## EME166 MOD FOR LINEAR AMPLIFIER SWITCHING

DRAWN	MINI-KITS
DATE	31-5-2013
PROJECT	TRANSVERTER SEQUENCER
FILE	EME166 P-CH Mosfet.SKF

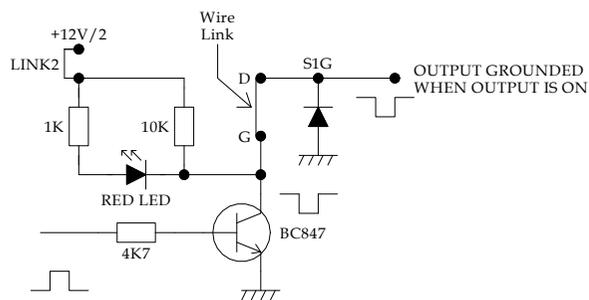
- 1/ Remove the NDT2955 MosFET from the board.
- 2/ Bridge the pads with wire that were originally connected to the MosFET Gate & Drain connections.
- 3/ This mod will allow the switching of Linear Amplifiers that require a grounded input to switch to TX mode.
